#	DOCUMENT	EXECUTIVE SUMMARY	TOTAL PAGES
01	Executive Summary of Submittal	<i>see pgs. 1-3</i>	3
02	Site Plan Check List		7
03	Subdivision Check List		6
04	Conditional Use Letters from Law Office of John Kuzinevich dated 12/27/19 and 5/15/20 (CUP)		8
05	Waiver Request Letter (Site Review and Subdivision)		1
06	Traffic Memorandum (Site Review and Subdivision)	<i>see pg. 4</i>	9
07	Plan Set of the "The Village at Banfield Woods", dated Sep. 25, 2019, last revised May 5, 2020 (Site Review, Subdivision, CUP)		50
08	Condominium Documents (Site Review and Subdivision)		32
09	Architectural Plans & Renderings (Site Review and Subdivision)		44
10	Letter Addressing TAC Conditions of Approval (Site Review and Subdivision)		6
11	Landscape Summary and Renderings of the Village at Banfield Woods (Site Review, Subdivision, CUP)	<i>see pg. 1</i>	18
12	August Consulting, PLLC Peer Review Summary (Site Review, Subdivision, CUP)	<i>see pgs. 1+2</i>	2

The Village at Banfield Woods **Executive Summary of Submittal**

R-TANKS - PROFILE VIEW
NOT TO SCALE

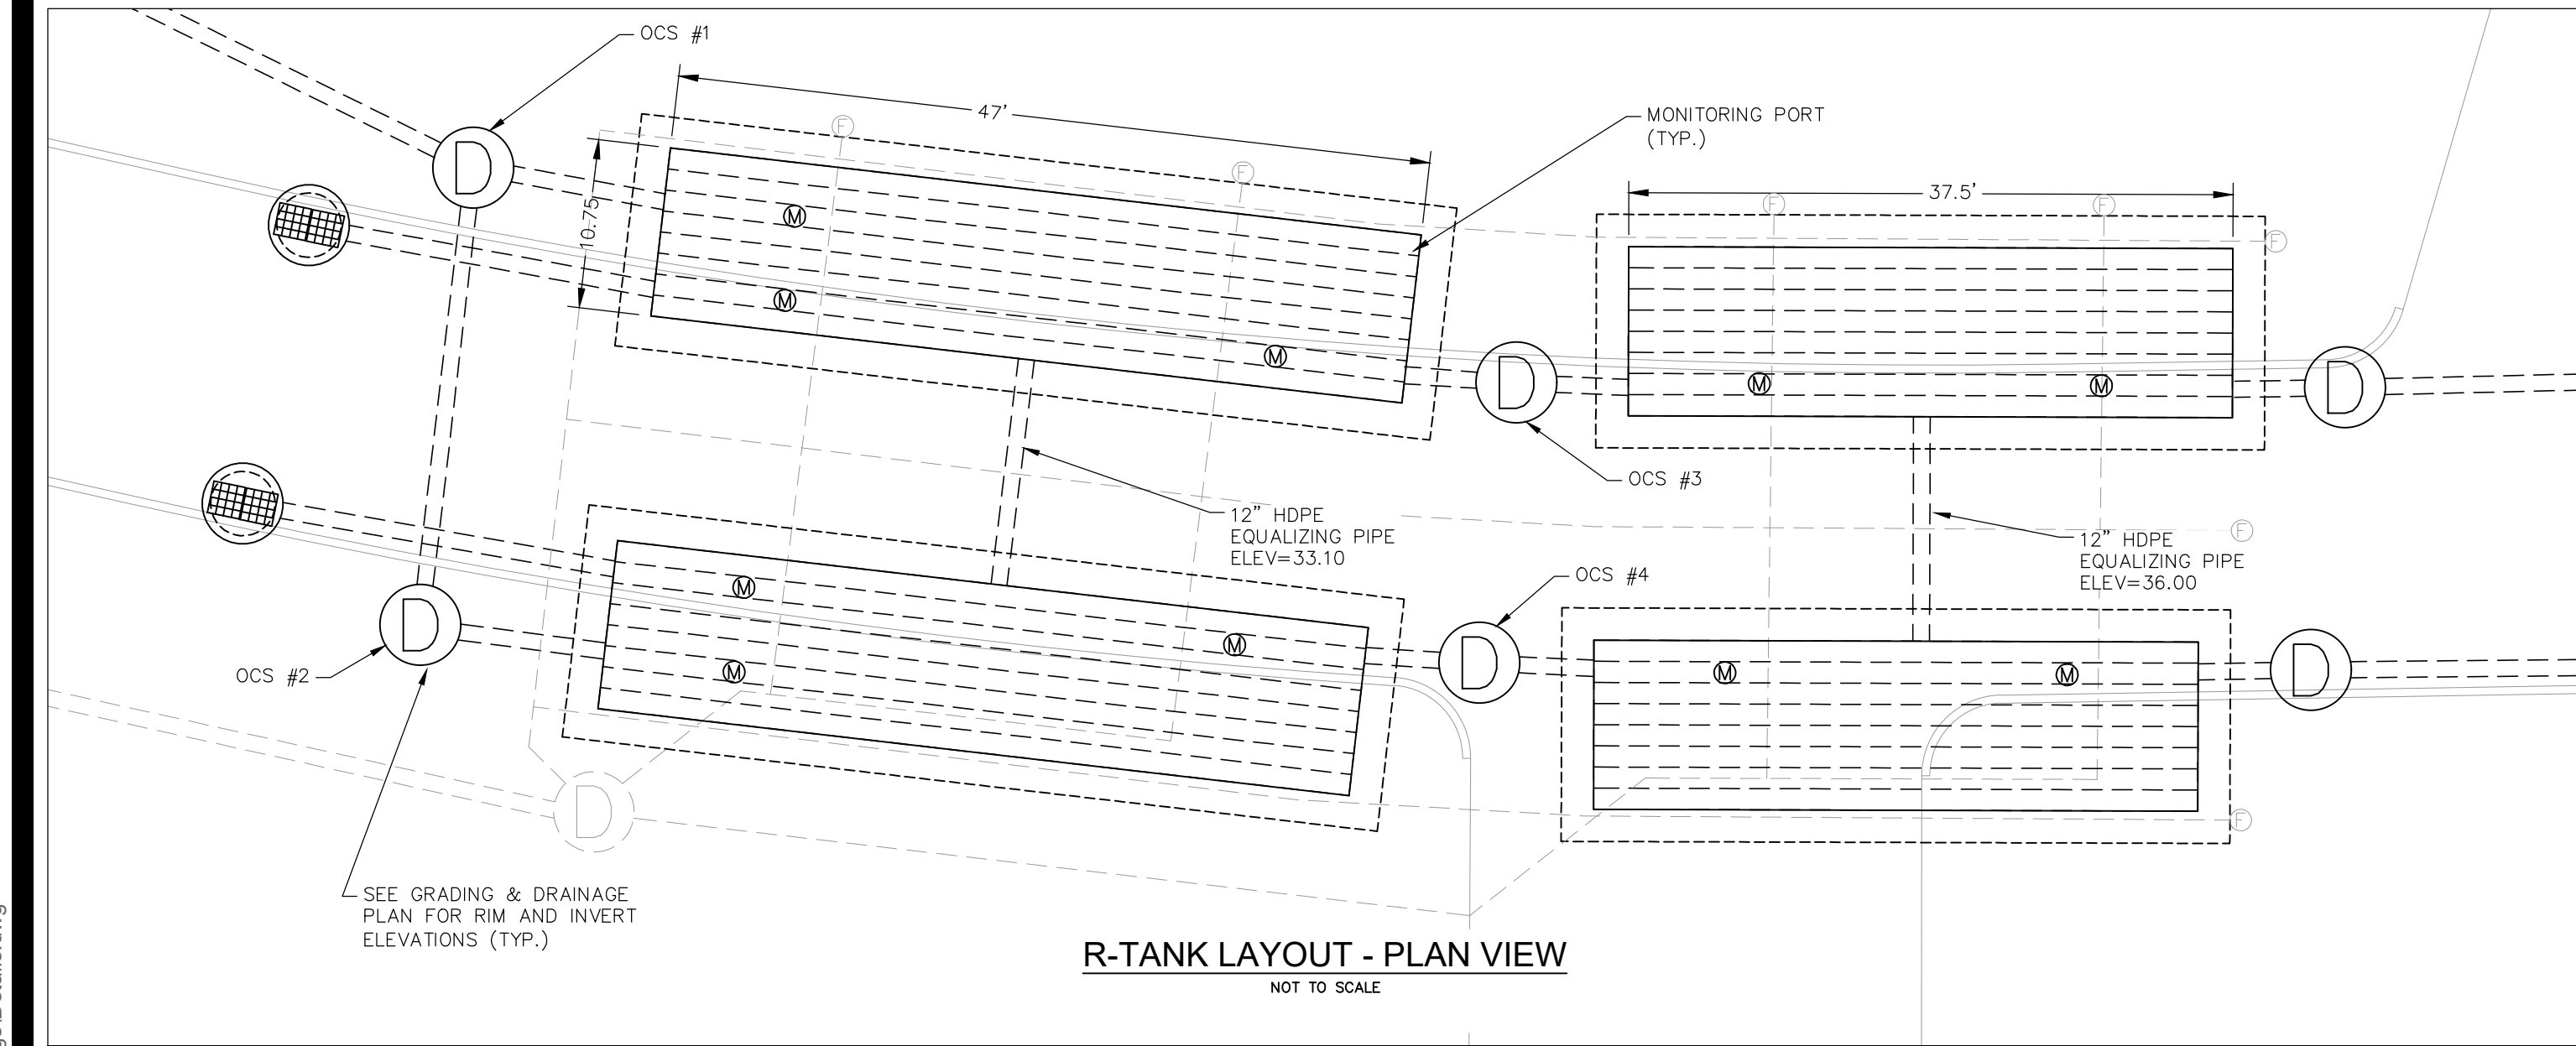
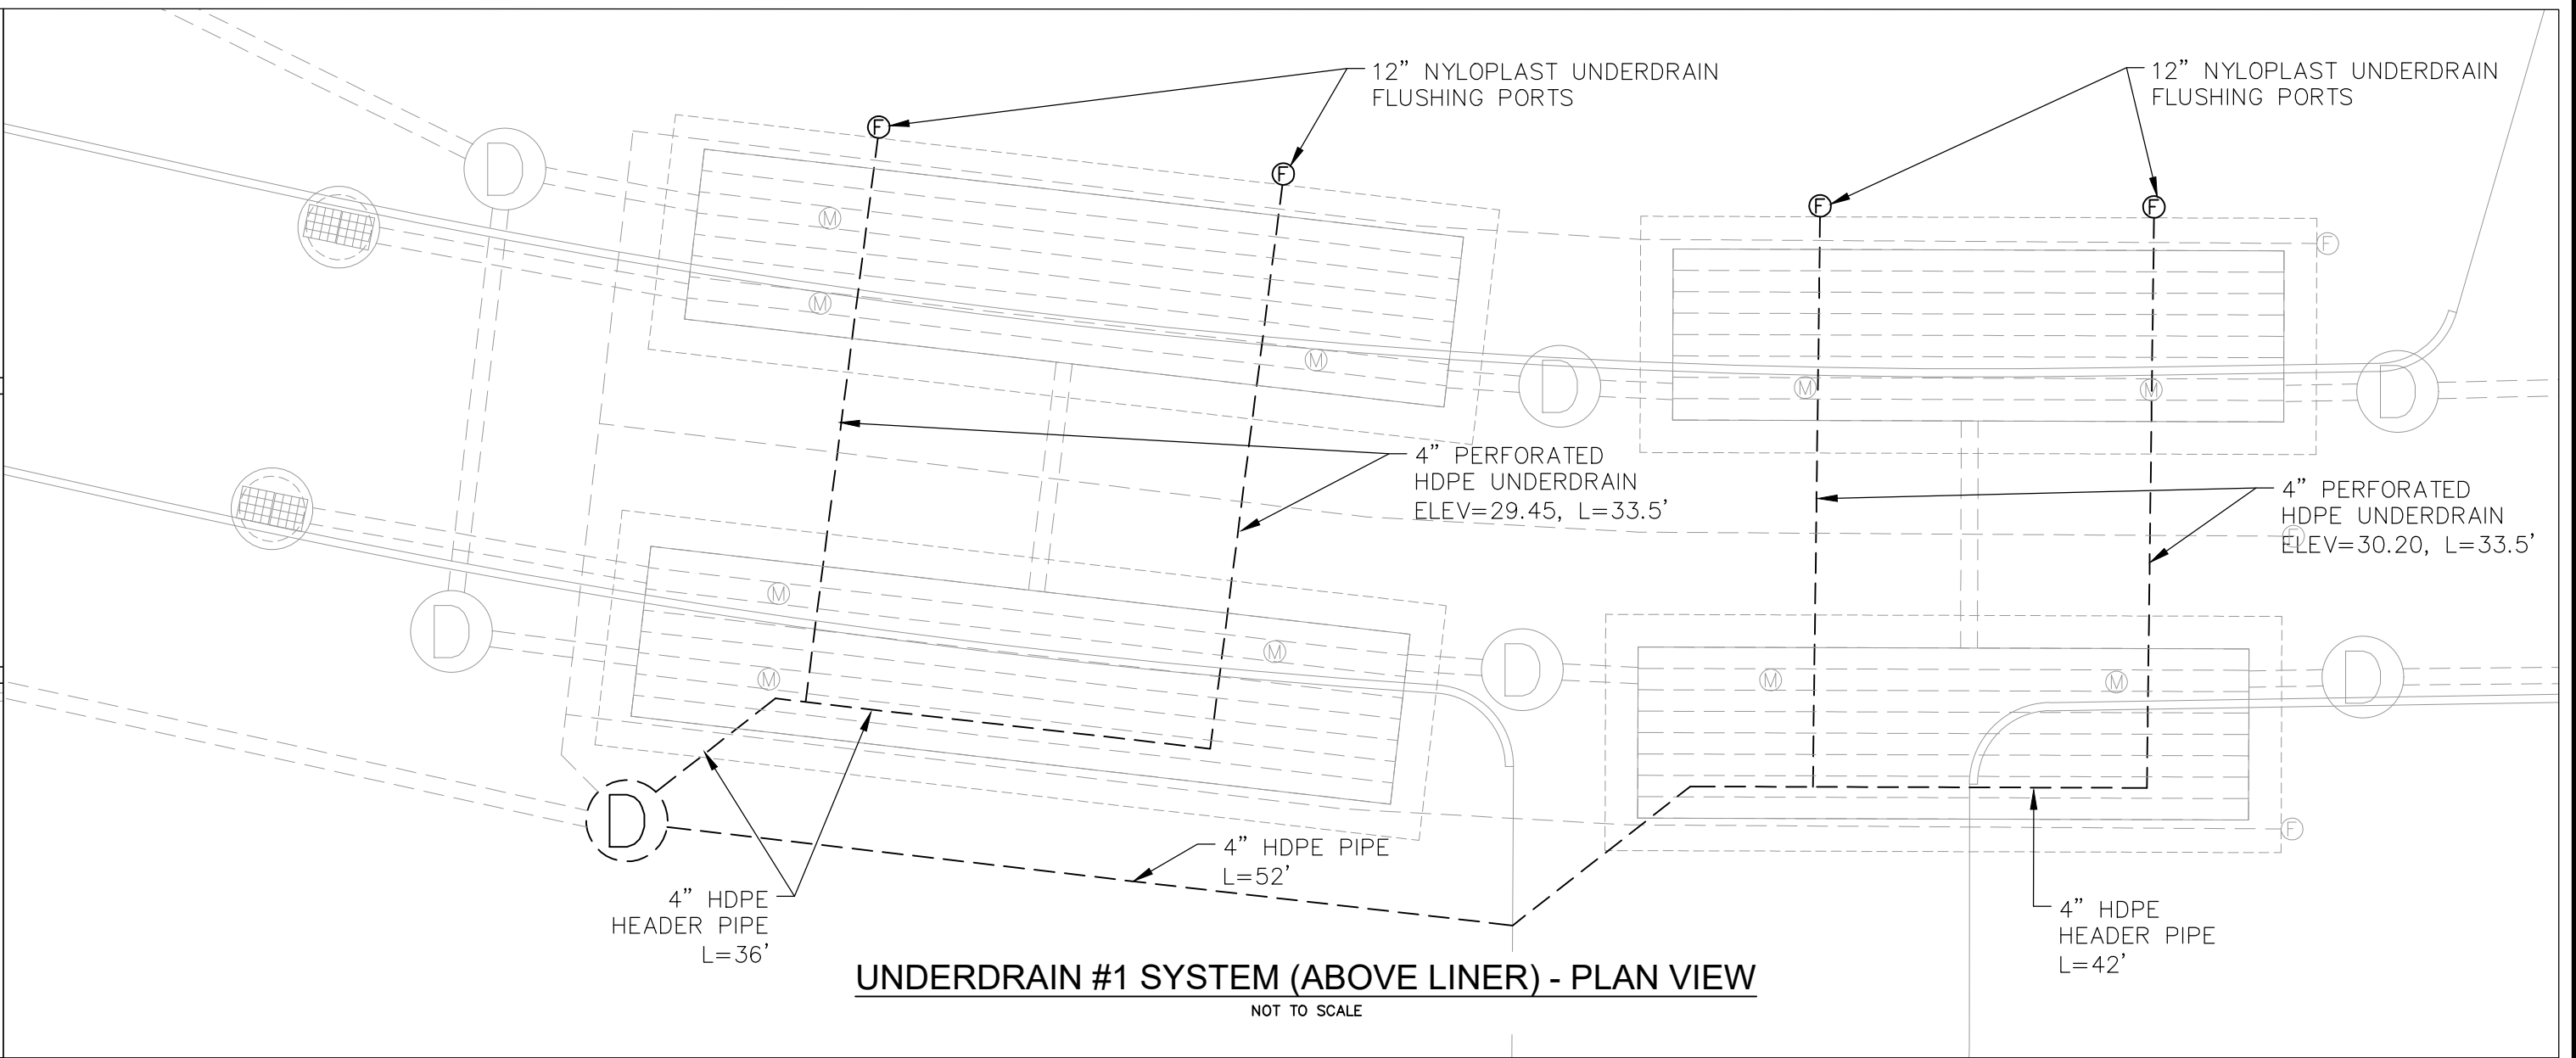
The R-Tank SD used in this application for HS-20 loads require a minimum of 18” of cover and a maximum of 108” to maintain a maximum load bearing capacity 42.9 PSI with a factor of safety ranging from 2.1 to 3.75 respectively. Sheet C-35 appears to detail more than sufficient cover to maintain load bearing capacity.

- Filter course specifications needed.** *Sheet C-35 lists a filter layer at the base of the R-Tanks. I do not see a specification for the filter layer for the subsurface detention and filtration.*
Revision: The filter course is an ASTM C33 sand with less than 2% passing the #200 sieve and is in accord with other designs I have worked with in the past.

- Maintenance ports.** *Sheet C-35 provides a detail for a maintenance port however the locations and number of ports are not detailed in the long-section or on the grading and drainage sheet C-10.*
Revision: The locations and number of ports are now detailed in the long-section on C-39 and on the grading and drainage sheet C-10. There are 2 maintenance ports shown on each R-Tank system with the specific location identified. This allows for proper monitoring of the system.
